13.2.1 DRAFT STRUCTURE PLAN - SOUTHERN RIVER PRECINCT 2 PHASE 3

Director:	C Terelinck
Author's Declaration of Interest:	Nil.
Reference:	Various.
Application No:	PF15/00007
Applicant:	Dynamic Planning & Developments
Owner:	Various
Location:	Area bound by Holmes Street, Balfour Street and Bush Forever Site 125.
Zoning: MRS:	Urban, Parks and Recreation
TPS No. 6:	Residential Development
Review Rights:	Yes. State Administrative Tribunal against a decision by the Western Australian Planning Commission to not approve the amendment.
Area:	22.97ha
Previous Ref:	Nil.
Appendices:	13.2.1A Draft Southern River Precinct 2 Phase 3 Structure Plan 13.2.1B Schedule of Submissions

For Council to consider whether to endorse a proposed Structure Plan for the Southern River Precinct 2 Phase 3 area, following the conclusion of public consultation.

A copy of the proposed structure plan is contained as Appendix 13.2.1A.

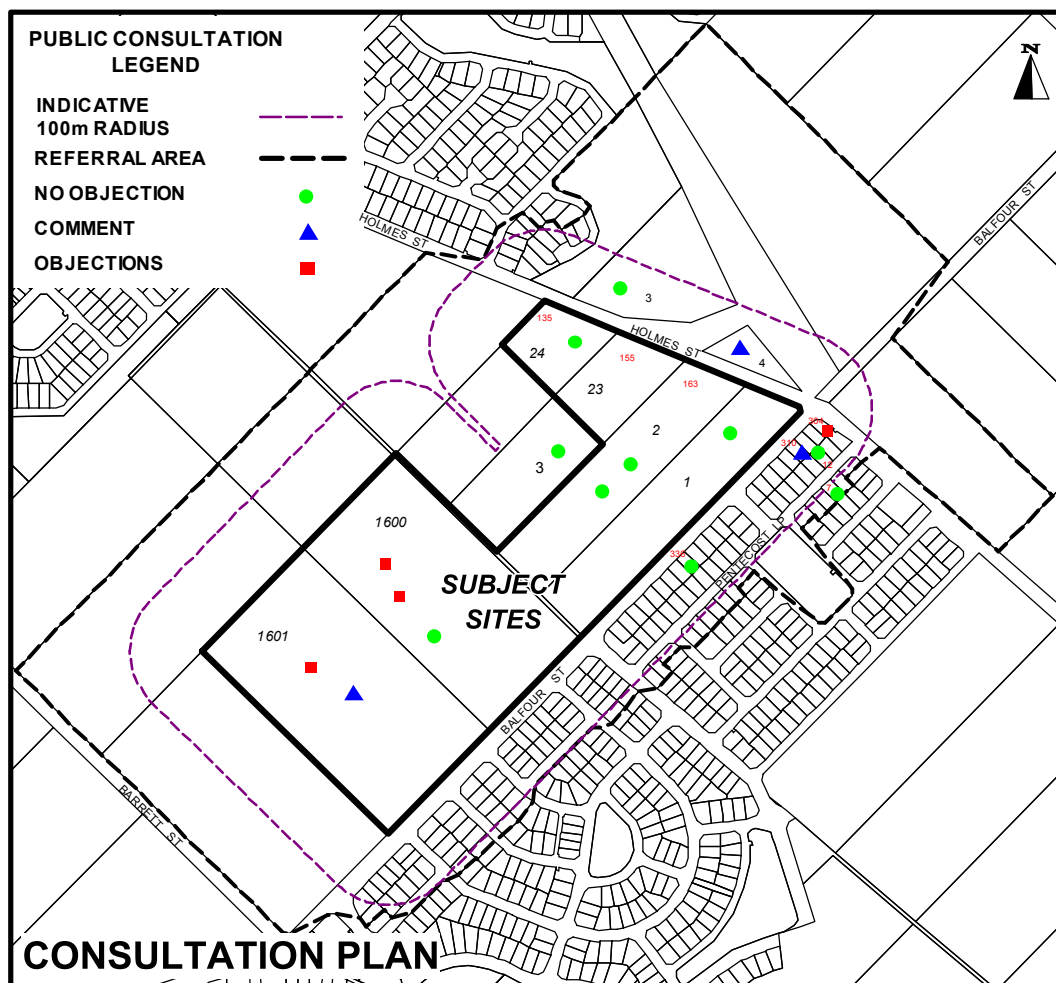
Notwithstanding the above, a submission was received from the landowners of Lot 1601 objecting to being required to cede more than 10% of their developable land area as POS. Lot 1601 has a land area of 7.2865ha, of which 5.53ha is reserved as Parks and Recreation under the MRS, thereby leaving 1.7565ha of developable land. The Structure Plan is proposing to designate 0.34ha of the site as POS, representing approximately 19.36% of the site's developable area. It is important to note that unlike the other POS areas in the Structure Plan, the POS on Lot 1601 is not required for any

Based on the above, it is acknowledged that the POS provision for Lot 1601 is inequitable and therefore consideration should be given to reducing it to no more than 10% of the developable land, and allocating the requisite POS to another landholding within the Structure Plan area. It should be noted that providing the reduced POS area on Lot 1601 retains its rectangular configuration and will still allow the retention of the high quality vegetation on site.

Given that Lot 1600 has the largest amount of developable land and is proposed to have one of the lowest POS provisions in the Structure Plan area, it is considered that it would be most appropriate to increase the POS allocation on this lot. It is considered that this could be accommodated on land abutting the south-eastern edge of the proposed POS on the site and west of the proposed POS on Lot 1, subject to the minor reconfiguration of the adjoining subdivisional road.

In terms of the suggestion of providing a cul-de-sac, it should be noted that Liveable Neighbourhoods discourages cul-de-sacs which exceed 120m in length. The existing Balfour Street reserve (to be reclassified to a lower order road) is approximately 140m in length, and therefore a cul-de-sac arrangement is not supported.

The application proposes three intersections to the realigned Holmes Street, with the most notable intersection being the full movement Balfour Street intersection. It also proposes two intersections situated north-west of the proposed Balfour Street intersection, with one of those intersections being left-in/left-out access only, and the other being full movement access. It should be noted that the intersections are proposed to be spaced approximately 60m apart and staggered around an existing intersection on the opposite side of Holmes Street. The proposed left-in/left-out and full movement intersections are proposed to be staggered 10m and 20m, respectively from this existing intersection.

In accordance with Liveable Neighbourhoods, these intersections should be staggered a minimum distance of 40m from one another. As such, it is considered that these intersections should be removed and the road layout modified to form a "loop road" configuration.

In terms of the Balfour Street intersection, given that it connects to another distributor road, it is likely to accommodate large volumes of traffic (in excess of 4,000 vehicles per day). For this reason, it is considered appropriate to control this intersection with a roundabout treatment.

The Structure Plan proposes two intersections to Balfour Street, located south-west of the Marnbu Road intersection, which will be staggered less than 20m from the existing Kempster Way and Millway Avenue intersections on Balfour Street (Note: the draft Structure Plan incorrectly labels Kempster Way as Millway Avenue). Given that these intersections are required to provide a logical road layout for the Structure Plan area and provide for emergency bushfire access, it is considered that these intersections should be maintained but modified so as to provide for left-in/left-out access only.

The Structure Plan provides for a footpath network throughout the area. In accordance with the requirements of Liveable Neighbourhoods, footpaths should be provided on all streets. The Structure Plan does not provide footpath links on all streets, including on parts of Lot 1600, Lot 1601 and sections of Balfour Street. Furthermore, the Structure Plan does not make provision for the realignment of the shared path network, which currently runs along Balfour Street, to coincide with the deviation of Balfour Street.

For the abovementioned reasons, it is considered appropriate to maintain the road alignments as proposed. In terms of Lot 1600, the submitter suggested that the existing dwelling should be shown indicatively on the Structure Plan, as has been done for Lot 1601. Given that such an annotation would be purely illustrative, this suggestion is acceptable.

No.	Recommended Modification and/or Information Requirement	Reason(s)
1.	<p>Modify the Public Open Space allocation of the Structure Plan, as follows:</p> <ul style="list-style-type: none"> (i) Reduce the Public Open Space provision on Lot 1601 from 3,400m² to 10% of the developable land on the site (ie approximately 1,757m²) and adjusting the adjoining road alignment accordingly. (ii) Increase the Public Open Space provision on Lot 1600 abutting the south-eastern edge of the proposed Public Open Space on the site and west of the proposed Public Open Space on Lot 1, and adjusting the adjoining road alignment accordingly. <p>The resultant modification shall ensure that the Structure Plan satisfies the standard 10% Public Open Space requirement and any other requirements as outlined in Liveable Neighbourhoods.</p>	To provide a fair and equitable distribution of Public Open Space in the Structure Plan area.

No.	Recommended Modification and/or Information Requirement	Reason(s)
	parkland design.	
3.	Modify the Structure Plan to indicatively show the existing dwelling on Lot 1600.	To recognise the presence of an existing dwelling.

4.	Modify the Structure Plan to remove the two intersections located north-west of the Balfour Street intersection, and modify the road layout to be in a "loop road" configuration.	To provide adequate intersection separation in accordance with Liveable Neighbourhoods.

5.	Modify the Structure Plan to show a roundabout at the Balfour Street and Holmes Street intersection.	To accommodate large traffic volumes for connecting distributor roads.

6.	Modify the Structure Plan to designate two proposed intersections to Balfour Street, situated near the Kempster Way and Millway Avenue intersections as left-in/left-out access only.	To provide adequate intersection separation in accordance with Liveable Neighbourhoods.

7.	Modify the Structure Plan to provide for a footpath network on all streets within the Structure Plan area.	To meet the requirements of Liveable Neighbourhoods.

8.	Modify the Structure Plan to provide for a shared path along the deviated section of Balfour Street.	To provide connectivity along major routes.
9.	Endorsement of a Wetland Management Plan by the City, subject to any advice from the Department of Parks and Wildlife.	To address the protection of wetlands within the Structure Plan area.

14.	Modify the Structure Plan map to correctly name "Kempster Parkway".	To correct an error on the Structure Plan.
